**TOWN OF NEWBURGH
PLANNING BOARD
TECHNICAL REVIEW COMMENTS**

PROJECT NAME: FABULOUS EVENTS, INC.
PROJECT NO.: 22-23
PROJECT LOCATION: SECTION 34, BLOCK 2, LOT 25.2, 54, 76, 77
REVIEW DATE: 10 MARCH 2023
MEETING DATE: 16 MARCH 2023
PROJECT REPRESENTATIVE: LANC & TULLY – JOHN QUEENAN, P.E.

Re: Fabulous Events, Inc.
SBL: 34-2-25.2, 54, 76, 77
Site Plan – NYS Route 32

TOWN OF NEWBURGH FIRE PROTECTION
FLOW TO BLDG. CONNECTION DETAIL

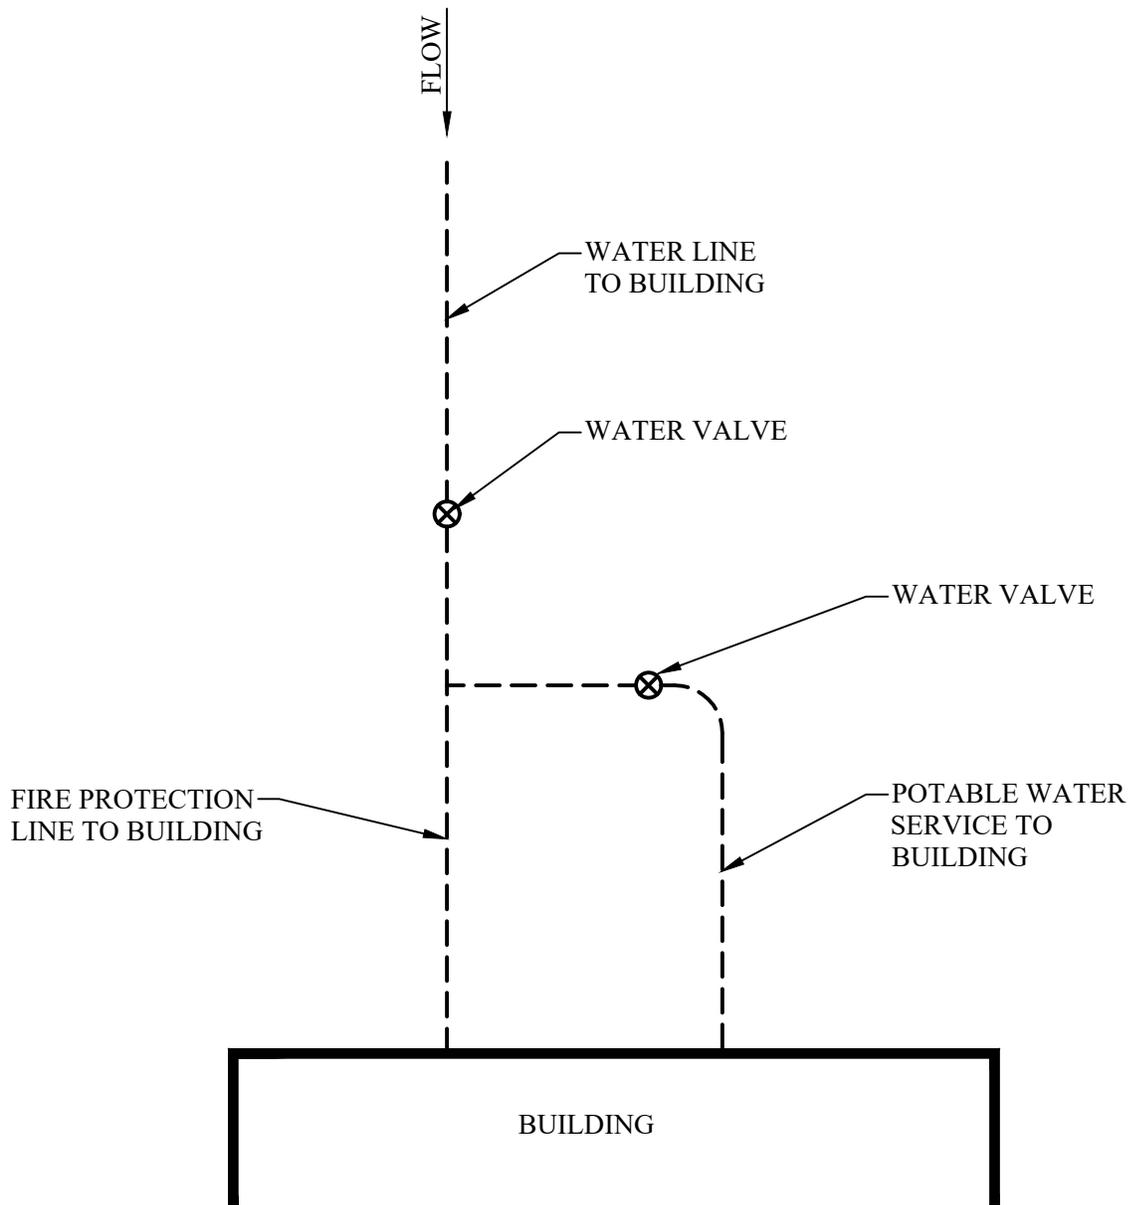
7. Sheet 3 of 8 continues to have outdoor storage notes on the plans. The Narrative has identified that outdoor storage would be removed.
8. The size of the water service should be depicted on the plans. The building will be required to have a sprinkler system. Water service should be sized for the water sprinkler and the potable water for the site. Typical detail is attached for the layout of the sprinkler/potable water.
